**Re: Response to WDNR's Correspondence dated September 9, 2020
Superior Health Linens / BRRTS #02-41-532649
5005 S. Packard Avenue
Cudahy, WI**

On behalf of D&C Partners, LLC (D&C Partners), St. John – Mittelhauser & Associates, Inc., a Terracon Company (SMA), has prepared the responses in this letter to address comments by the Wisconsin Department of Natural Resources (WDNR) in their letter dated September 9, 2020. Once we have satisfactorily addressed these WDNR comments, we anticipate preparing a Site Investigation / Remedial Action Options and Design Report Addendum (SI/RAODR Addendum) for the Superior Health Linens (Superior) site for submission to the WDNR.

HISTORICAL SOIL ANALYTICAL RESULTS (SHALLOW <5' BGS)

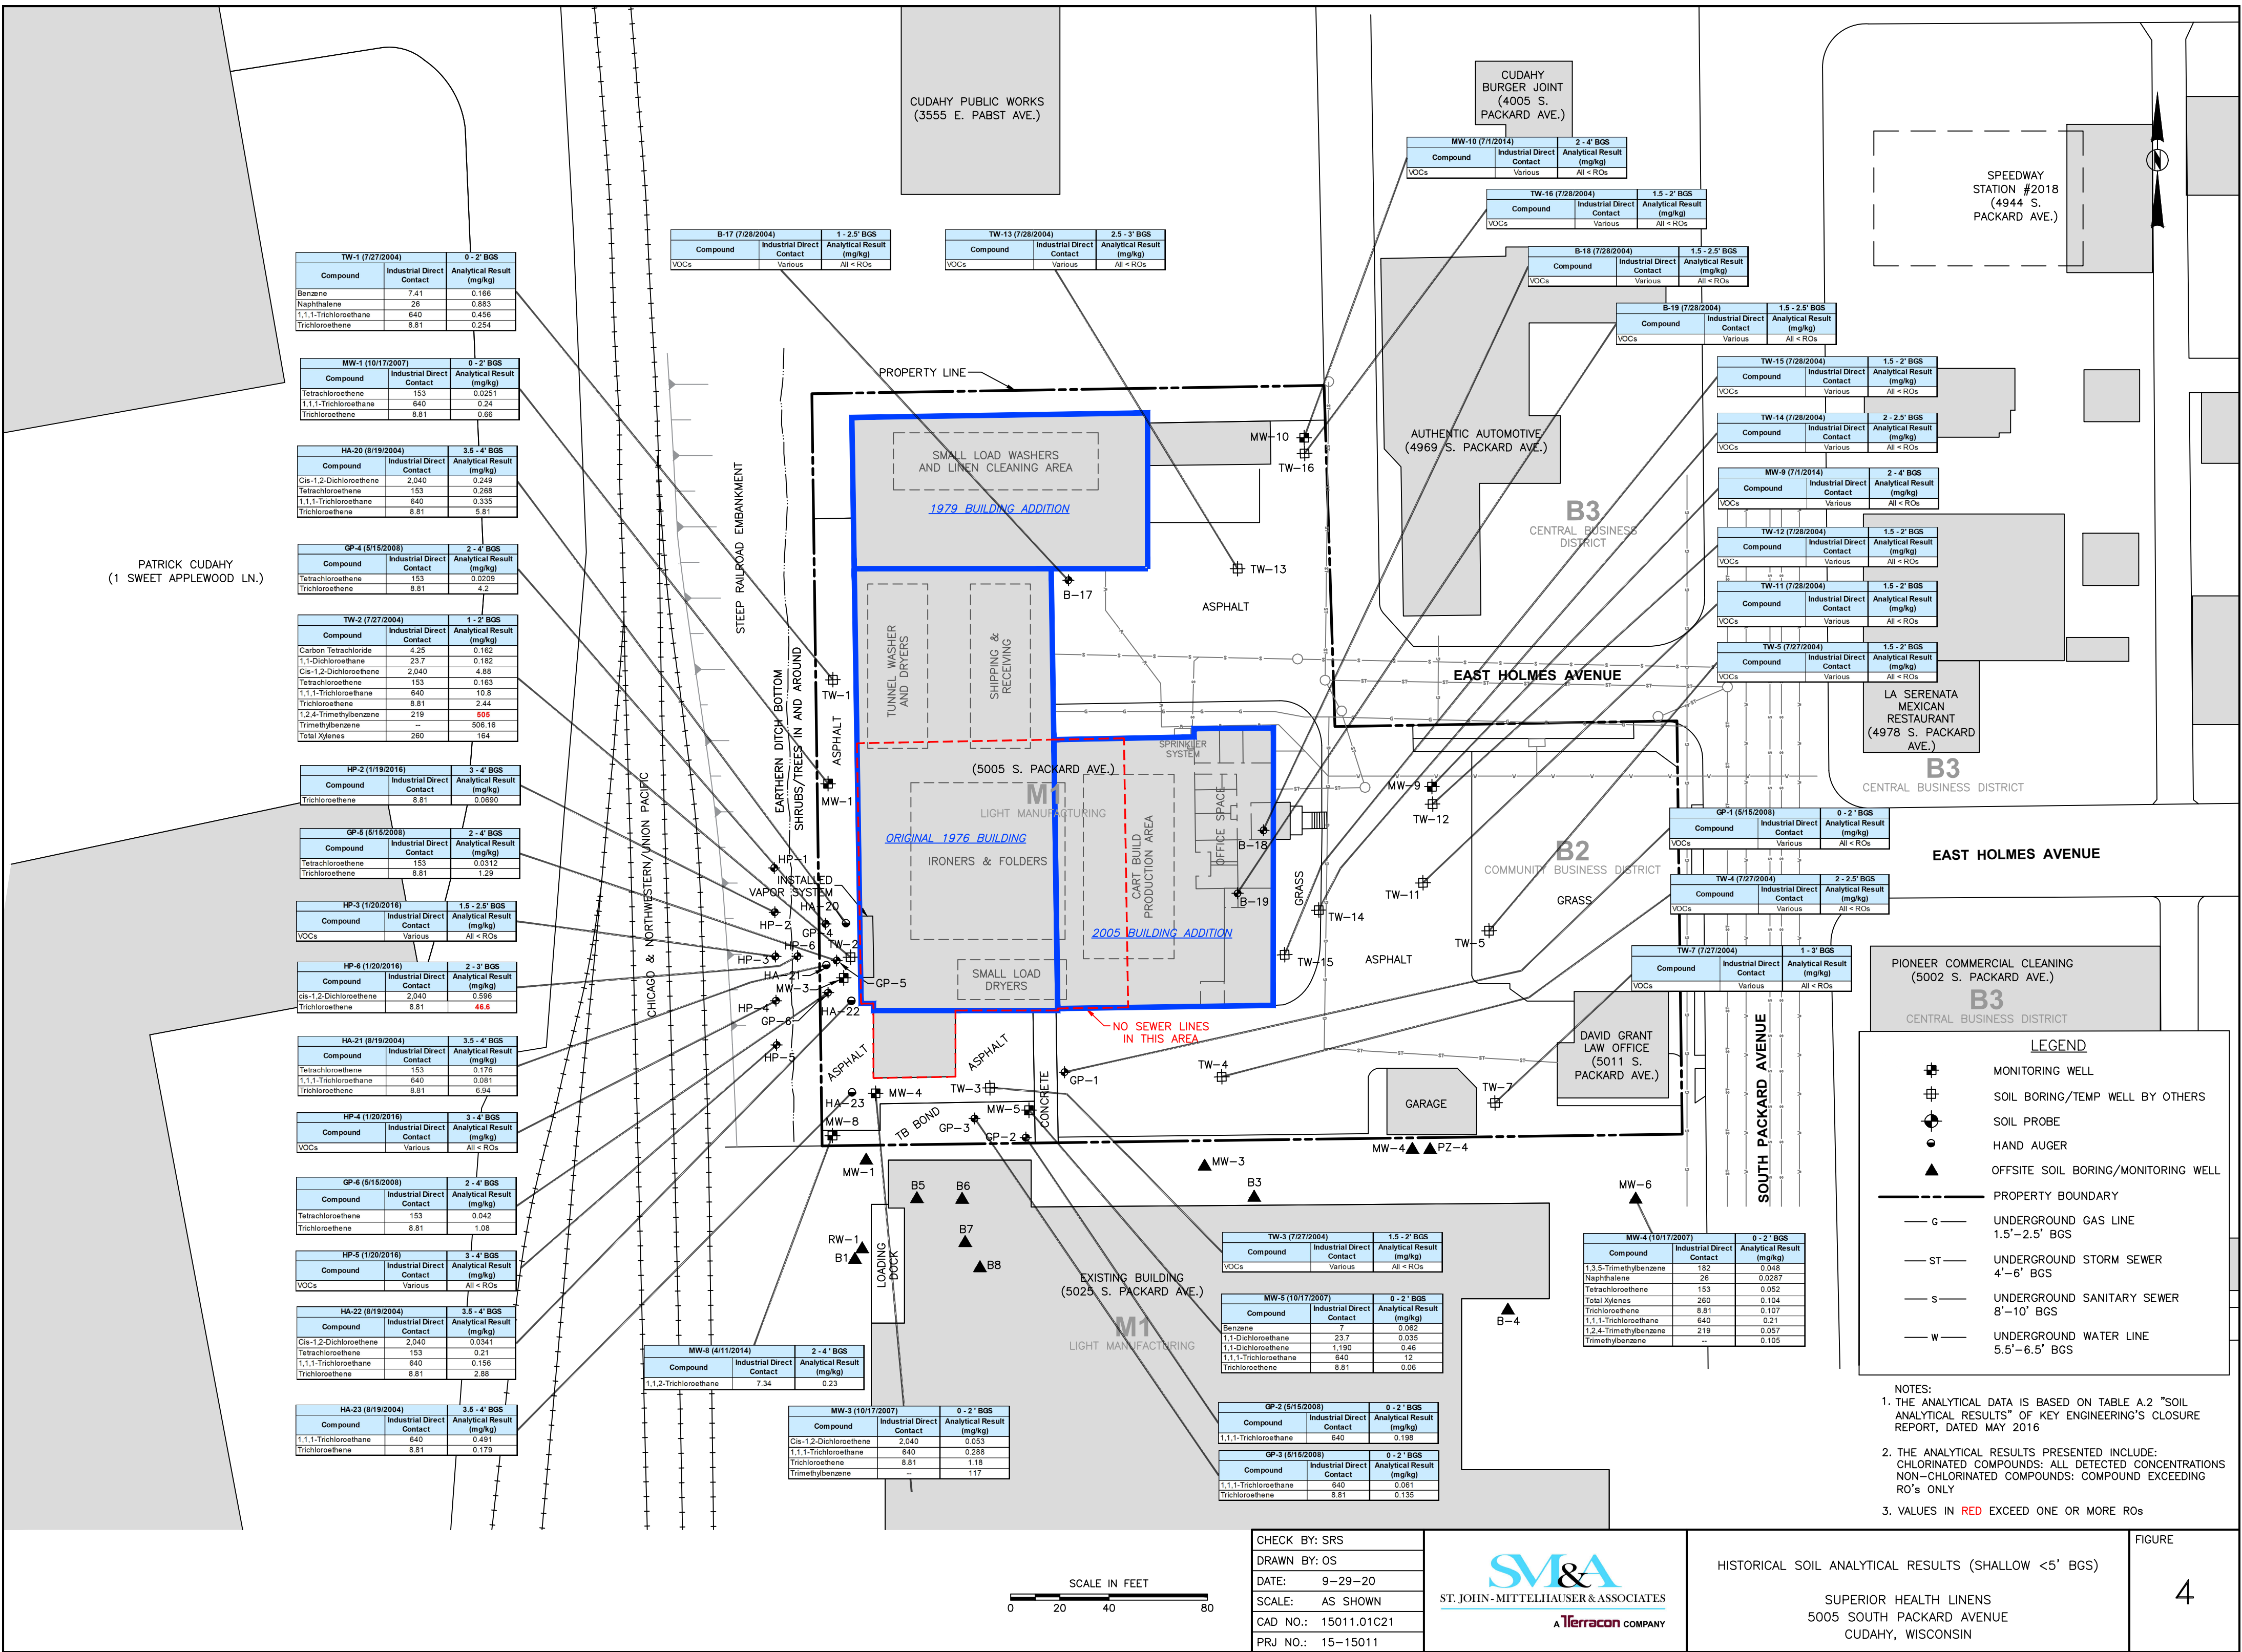
The construction of an impervious barrier has been proposed along the western side of the site to prevent exposure to residual contamination. To obtain closure, a cap must be maintained in areas where soil contaminant concentrations exceed the direct contact residual contaminant level at depths shallower than four feet. No additional capping is required to address groundwater contamination as the plume appears to be stable under current conditions. However, impervious surfaces currently in place over residual soil contamination will be required to be maintained as a condition of closure to ensure that groundwater will continue to improve. Before the DNR can concur with a capping plan the limits of contamination posing a direct contact risk needs to be identified to demonstrate that the cap will cover this area.

SMA has reviewed the soil analytical results with respect to the Industrial Direct Contact RCLs. The review identified two soil borings within the source area at the southwest corner of the property where contaminants exceeding the Industrial Direct Contact RCL values are present within 4 feet of the surface. These soil borings include:

Figure 4 has been updated to include a comparison of all samples collected within 4 feet of the surface to the Industrial Direct Contact RCLs. An updated Figure 4 is provided in Attachment A to this letter.

POTENTIAL EXTENT OF CONTAMINANTS EXCEEDING PROTECTION OF GROUNDWATER RCLs

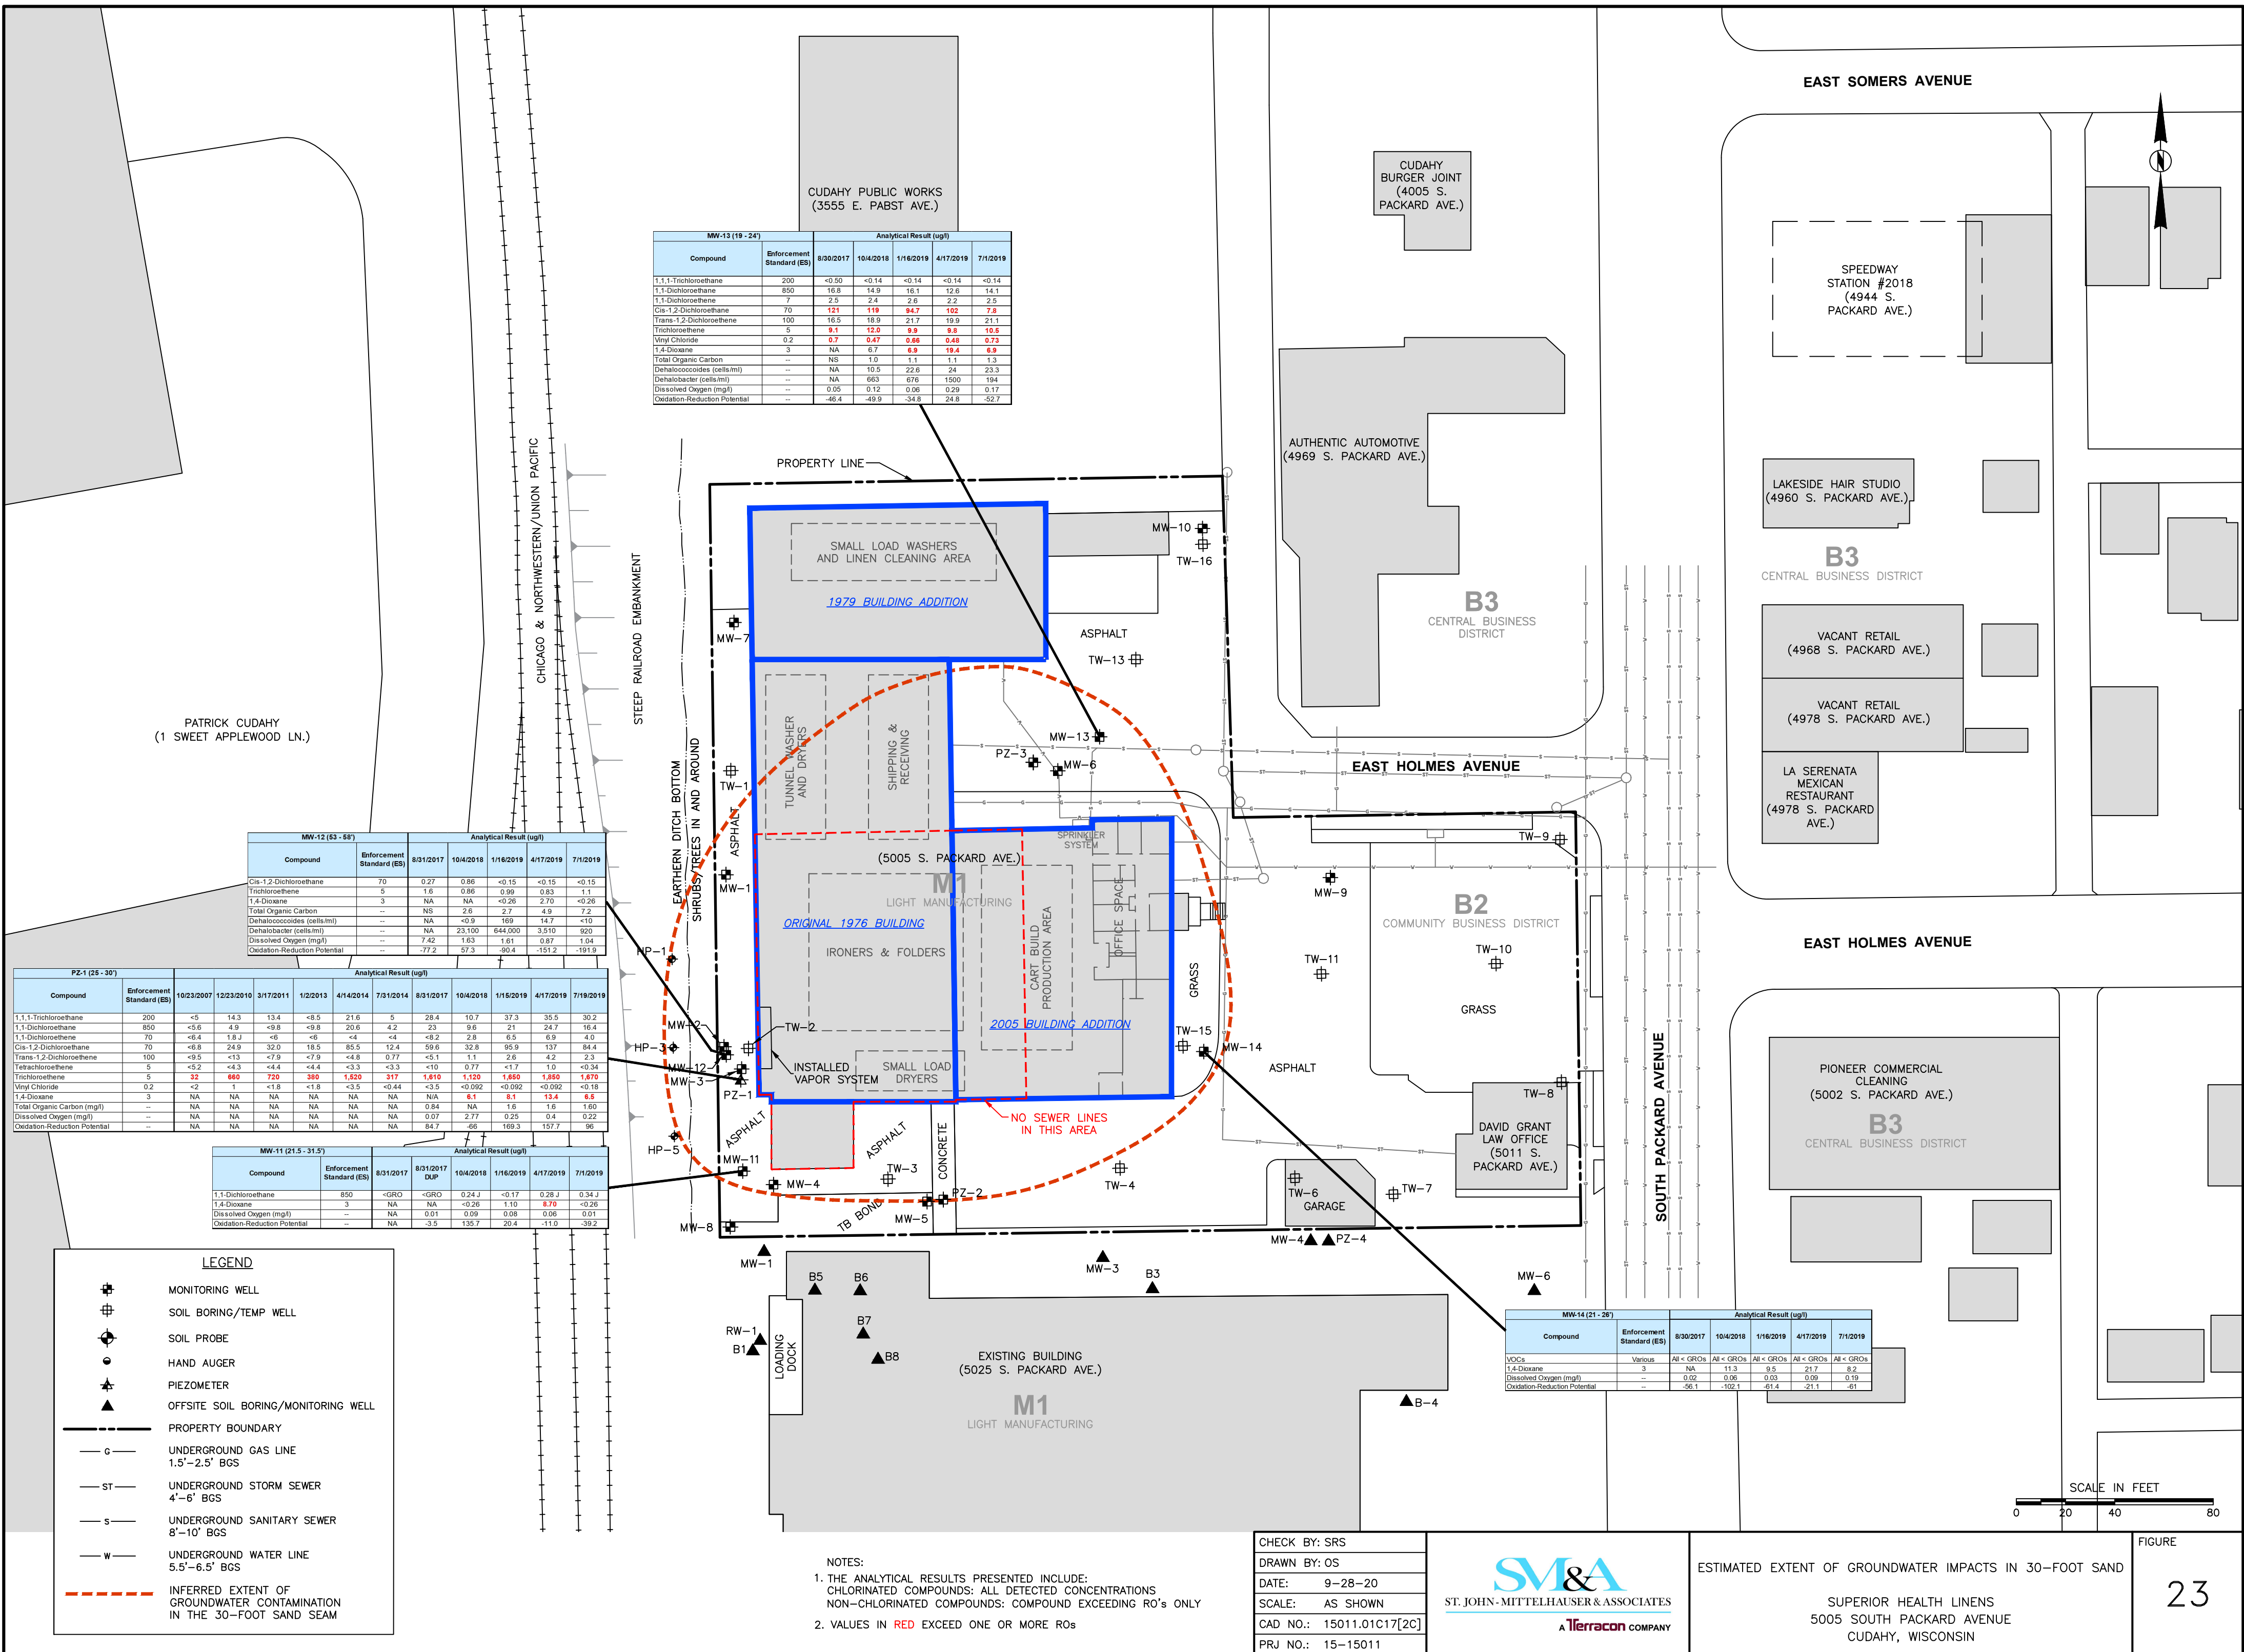
the extent of soil contamination is generally defined by the considerable number of samples collected on the west side of the property near the source area and along the eastern portion of the property. The extent of soil contamination under the building can be estimated, but not exactly defined, by the available data. No further investigation under the building will be required if the extent of contamination depicted on Figure 20 of the Report is expanded to cover a wider area to be better representative of potential soil contamination. The relatively high concentrations of volatile organic compounds detected in the source area suggests that plume may extent further under the building than shown. Having a larger plume displayed will do better to notify those who excavate soil or build on the property that residual contamination needs to be considered when conducting these activities. You may otherwise provide a detailed explanation as to how the extent of soil contamination is displayed correctly, which the DNR will review, or collect soil samples from under the building to more accurately define where contamination remains.

SMA is not aware of any site data (quantitative or qualitative) that suggests the presence of soil contamination under the building. However, SMA understands the WDNR's desire to increase the size of the area of potentially impacted soil depicted on Figure 20 to provide a more conservative notification to those who may excavate soil and/or build on the property in the future. Therefore, as suggested, Figure 20 has been revised to show an increased area of potentially impacted soil and is provided in Attachment A to this letter.
